Subject: AP1000 COL Standard Technical Report Submittal

Subject: AP1000 COL Standard Technical Report Submittal of Sensitive and Non-Sensitive Versions of APP-GW-GLR-033, Revision 0

APP-GW-GLR-033, Revision 0

## **Spent Fuel Storage Racks Structural/Seismic Analysis**

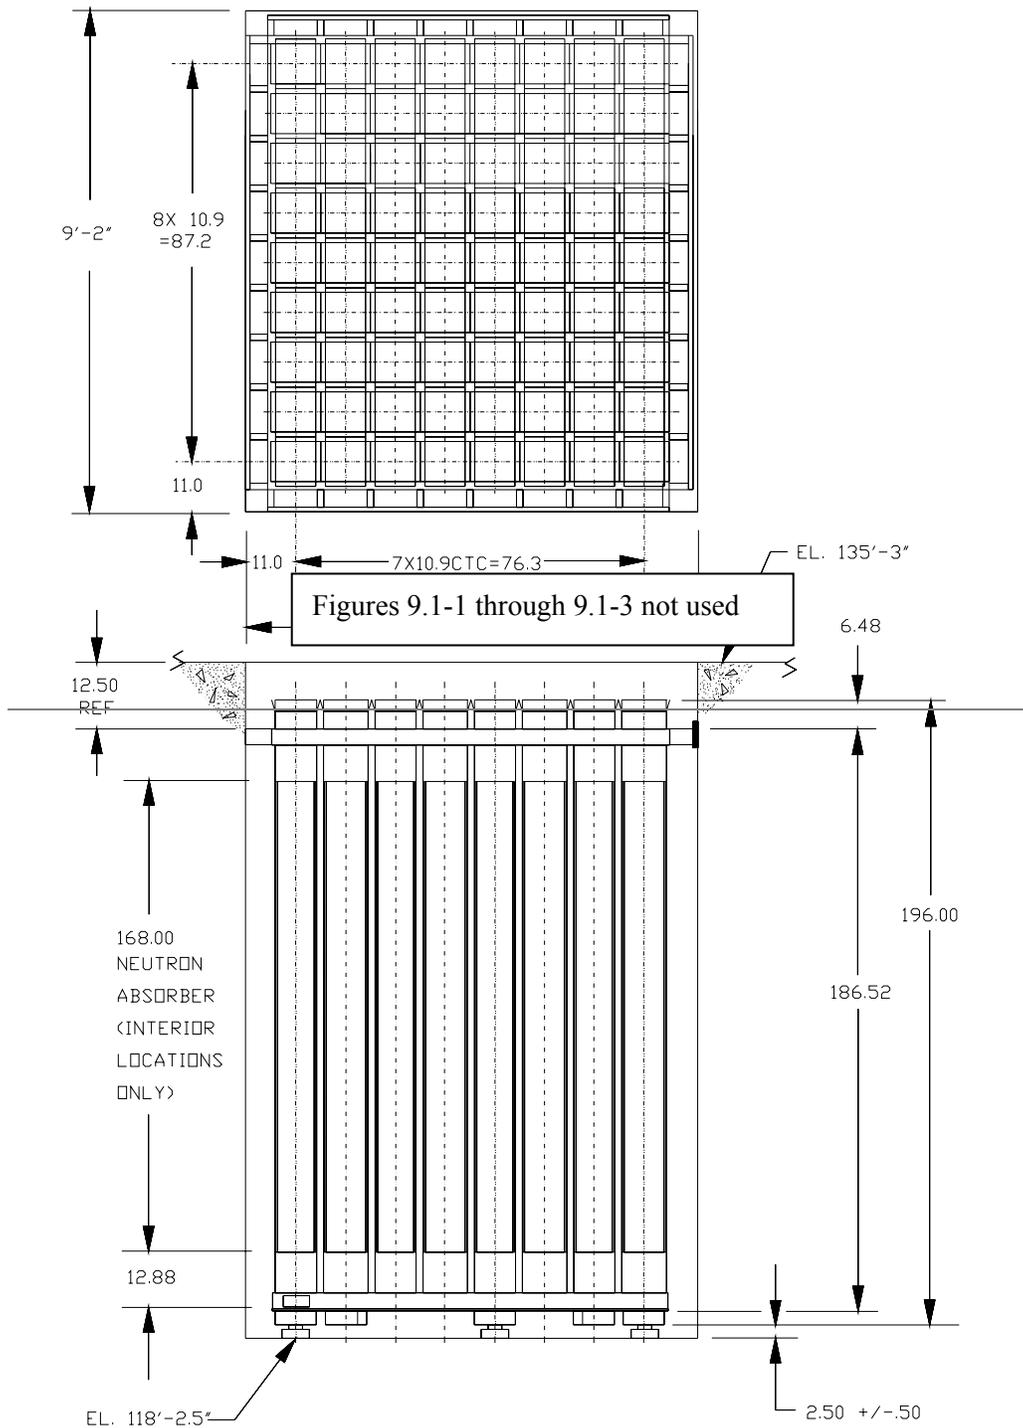
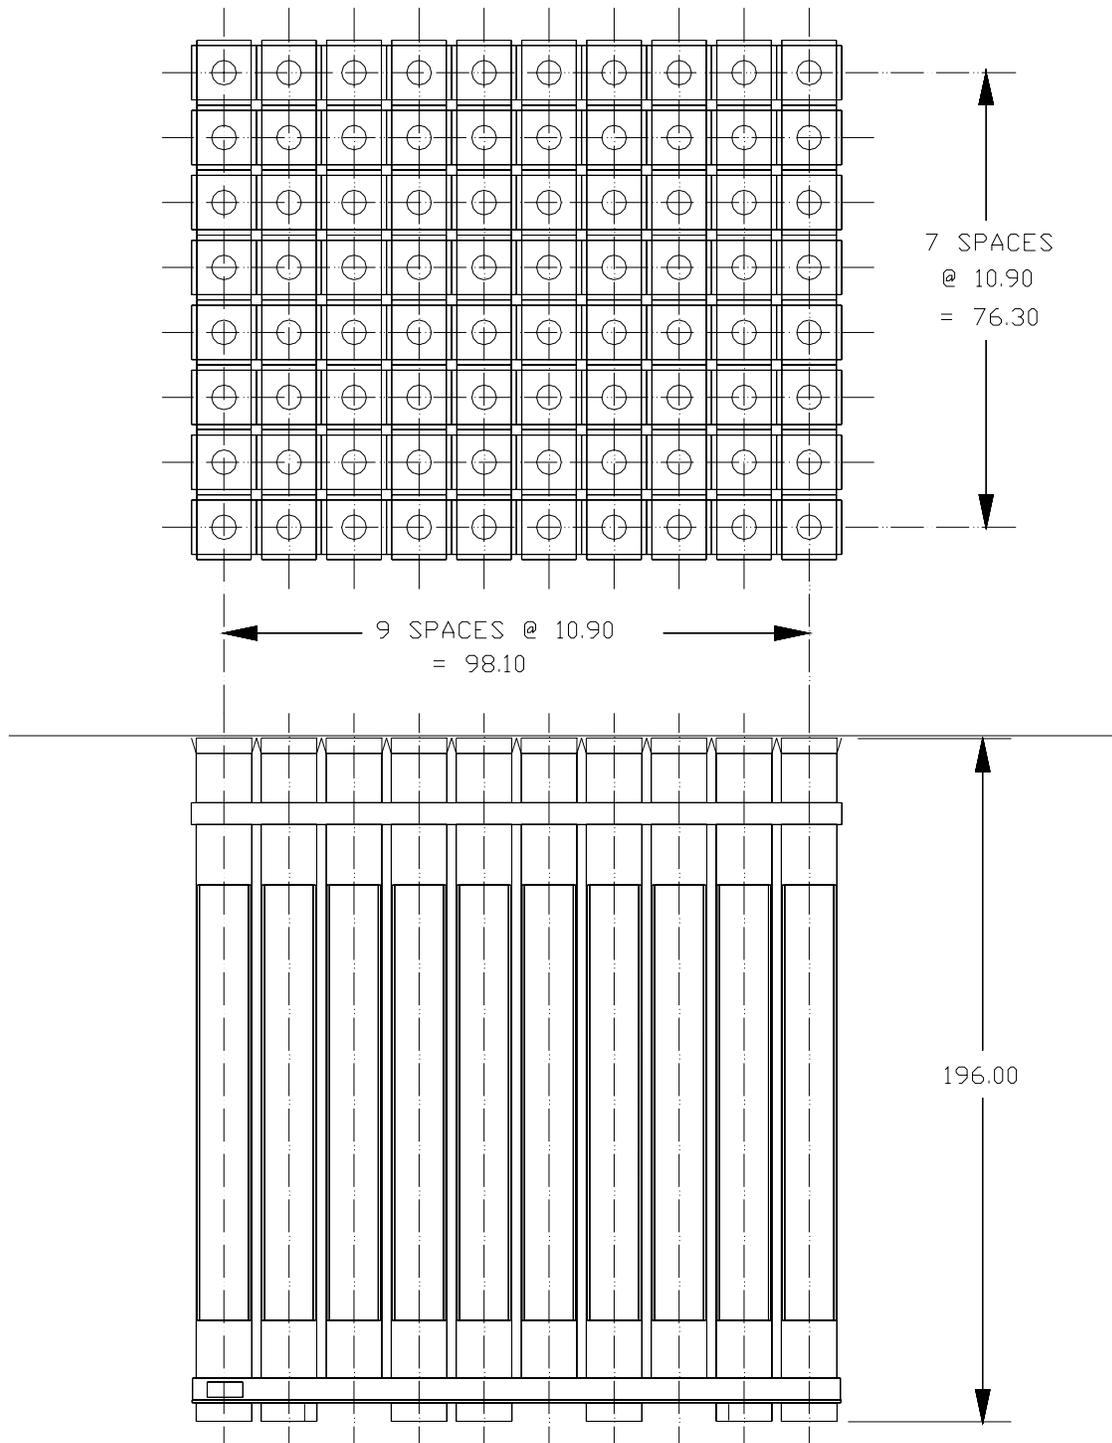
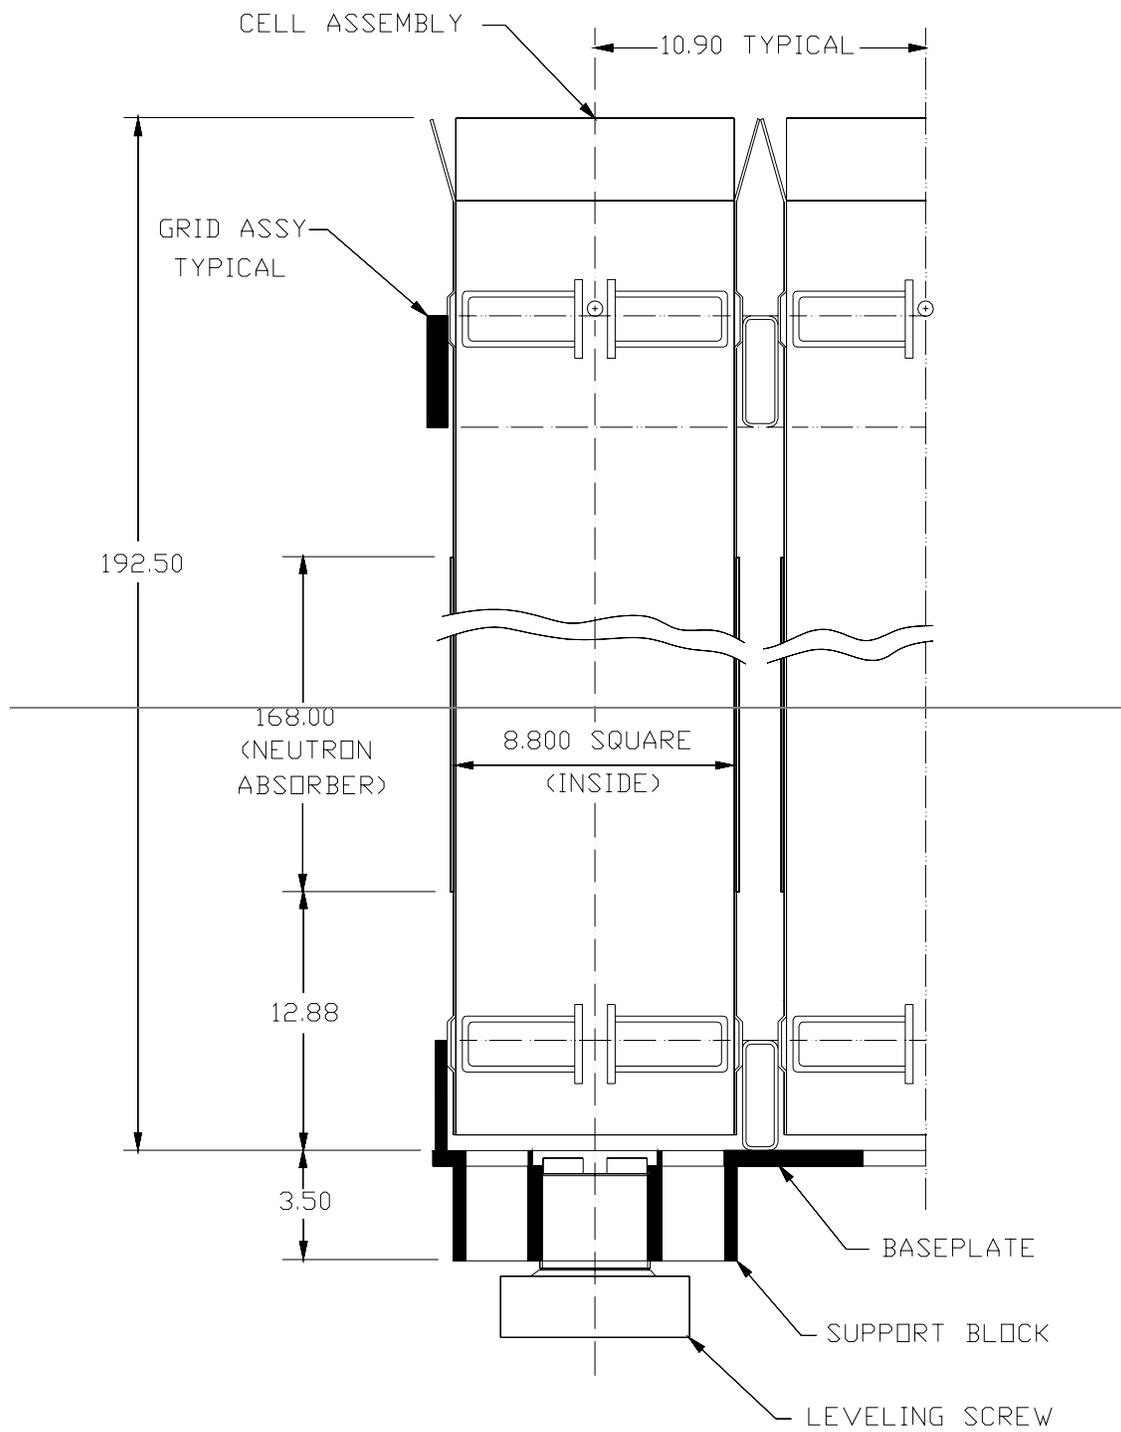
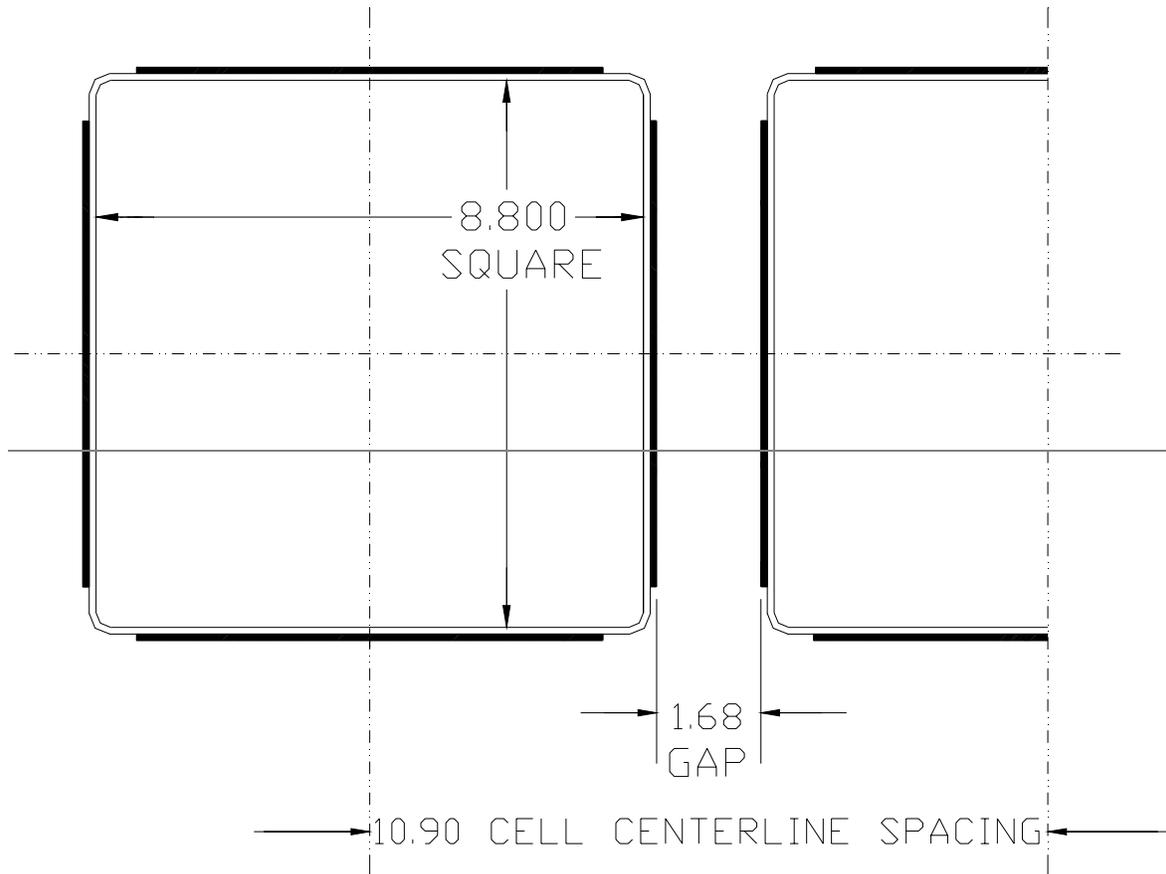
- Delete Figures 9.1-1 through 9.1-3 by indicating “Figures 9.1-1 through 9.1-3 not used.”
- Replace Figure 9.1-4 with a new Figure 9.1-4.
